NAME: TELMA WIRING DIAGRAM 2003 FORD F SERIES

REV: b PART NUMBER: TIL14022

QVM Bulletin No. – Q-88

## **2003 Model Year Super Duty F-Series Electrical System Changes**

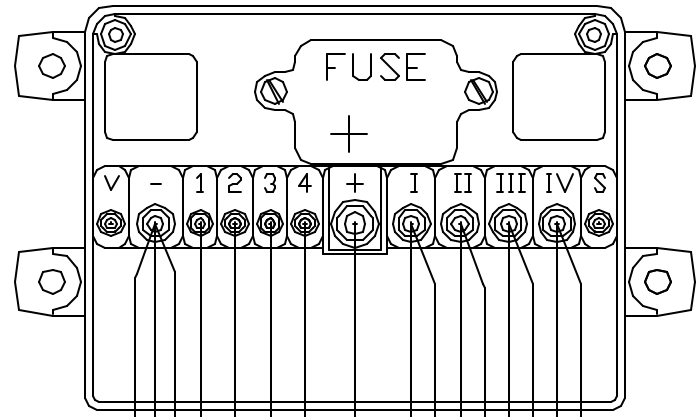
REVISIONS					
ZONE	LTR	DESCRIPTION	E.C.O.	DATE	APPROVAL
	b	NEW SPEED SIGNAL CONNECTION

2003 FORD F SERIES SPEED SIGNAL WITH 6.0L ENGINE CONNECT TO CIRCUIT 239 (WHT/ORG UNDER DASH AT PARKING BRAKE PEDAL
